Re: Goshen Coach
Defect and Non-Compliance Report

Subject: NHTSA Threshold Warning Signal Recall (Recall Number 06E-094)

Service Bulletin 34273

Instructions for Braun Corporation "Public and Private Use" Dual Parallel Arm Lift Threshold Sensitivity Evaluation and NHTSA Compliance Applicable for NL, NCL and NVL Series Lifts

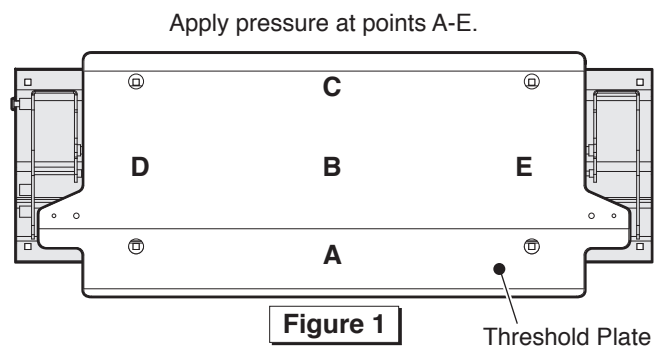
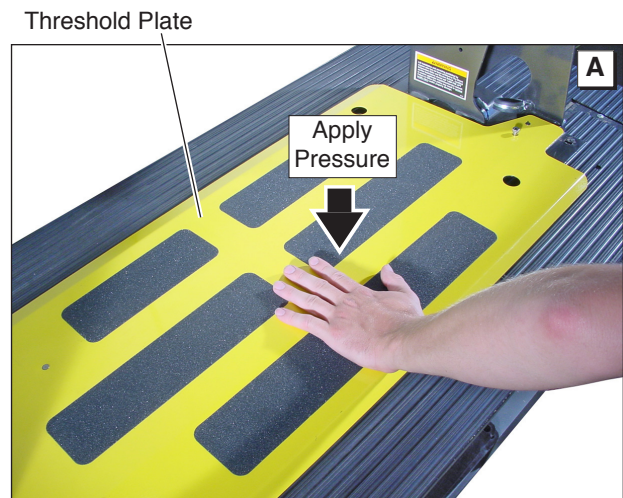
1. Turn Lift Power switch ON. Deploy the lift platform fully to the ground.
2. Apply hand pressure on the center of the threshold plate as shown in Photo A. The visual and/or audible threshold warning* should be activated when you push down.

Repeat the sensitivity test procedure at positions A-E shown in Figure 1.

3. If the threshold alarm is activated at all positions, no further procedures are required. The lift threshold sensitivity meets NHTSA FMVSS 403/404 requirements.

If the threshold alarm is not activated at all positions, perform the retrofit procedures detailed on pages 2 and 3 of this bulletin. Repeat the sensitivity test procedures following the retrofit. If the lift still does not meet the requirement, contact a Braun Corporation Product Support representative at 1-800-THE LIFT[®].

Threshold Sensitivity Retrofit Instructions

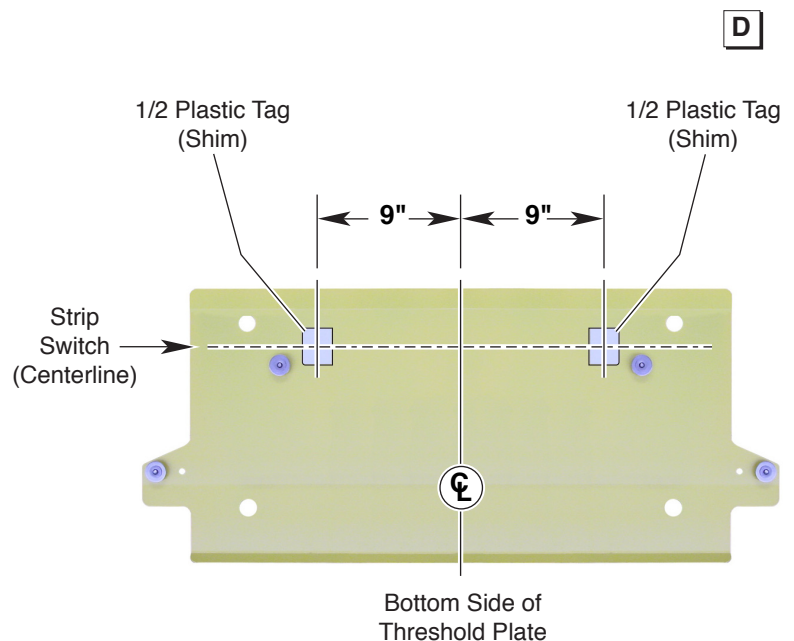
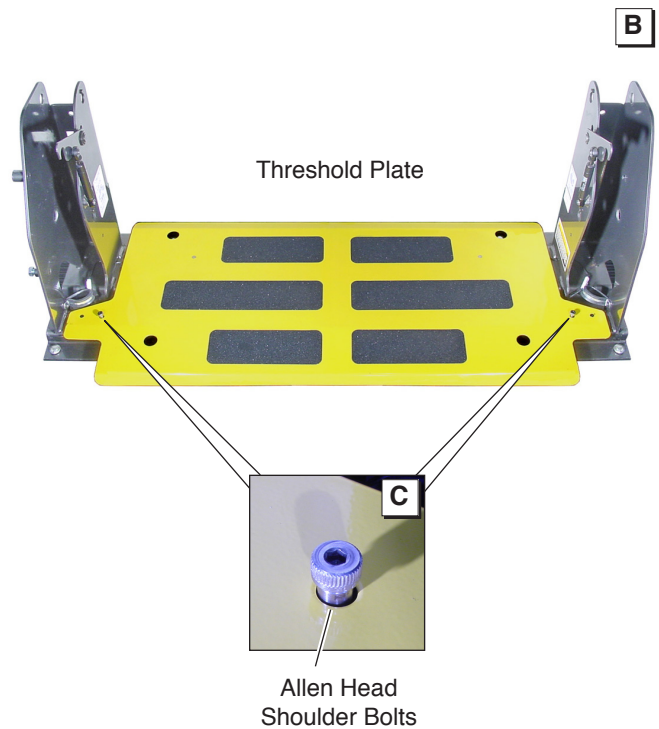
1. Turn Lift Power switch ON. Deploy the lift platform fully to the ground.
2. Remove the threshold plate. Loosen and remove two Allen head shoulder bolts securing the plate (see Photos B and C). Keep bolts. Slide the plate outward and lift to remove it (four keeper standoffs engage key-hole slots). See Photos E, F and G.
3. An adhesive-backed plastic tag is supplied to serve as an alarm activation shim (minimal thickness required to activate the highly sensitive alarm strip switches). Cut the plastic tag in two halves. The plastic tags (shims) will be affixed to the bottom side of the threshold plate (positioned as shown and detailed below).

Turn threshold plate over. See Photo D. The strip switches typically leave an impression (mark) on the yellow plate from use. Use the impression of the inboard strip switch as a centerline for shim positioning (or measure to establish position).

Position each shim 9" from the center of the threshold plate (see Photo D). Align the tags with the strip switch centerline. Clean the surface as detailed below and affix the adhesive-backed tag to the plate (**press firmly**).

Note: Clean the surface with isopropyl alcohol before affixing the tag. Use a clean cloth or paper towels. Do not use oily shop rags. Wipe surface free of residue with dry portion of cleaning cloth.

Threshold Sensitivity Retrofit Instructions

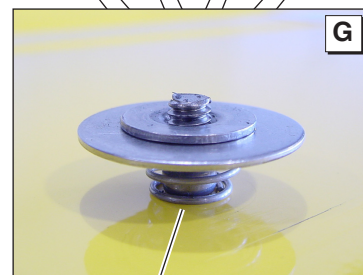
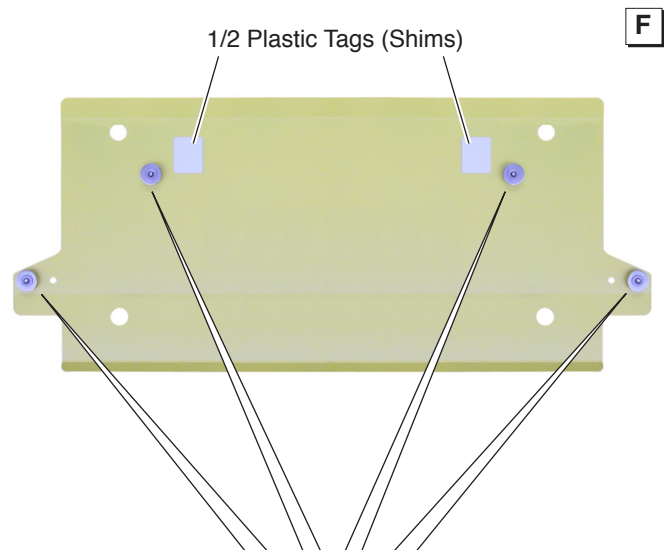
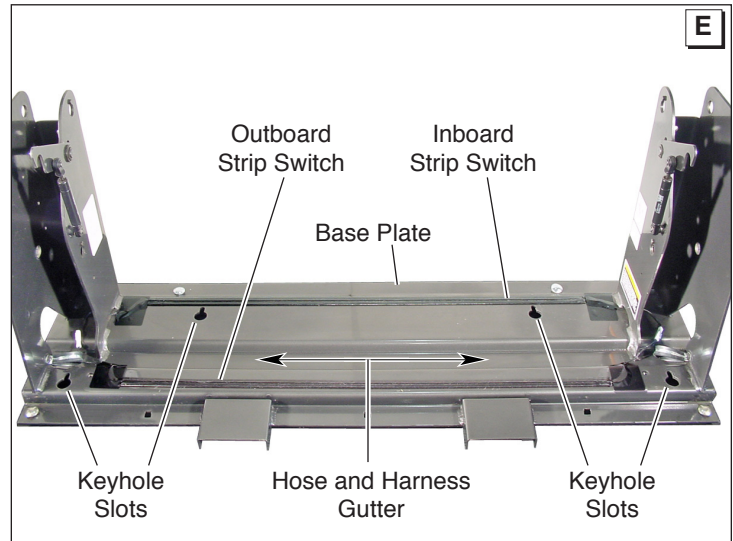
4. Reposition the threshold plate (with shim). Align the keeper standoffs (studs) on the bottom of the threshold plate with the base plate keyhole slots. See Photos E, F and G. Insert studs and **carefully** slide the plate inward (engage slots fully).

Ensure all hoses and wiring harnesses routed through the base plate gutter are positioned fully in the gutter and not located anywhere they could potentially interfere with activation of the tape switches. See Photo E.

Note: Spraying a light mist of glass cleaner (or other) to the strip switches will aid in the plate sliding easier into position. See Photos E, F and G.

Ensure all four keeper standoffs engage the base plate keyhole slots.

5. Reinstall the two Allen head shoulder bolts previously securing the plate (see Photo B and C). Tighten bolts securely.
6. Repeat the sensitivity test procedures outlined on page 1.
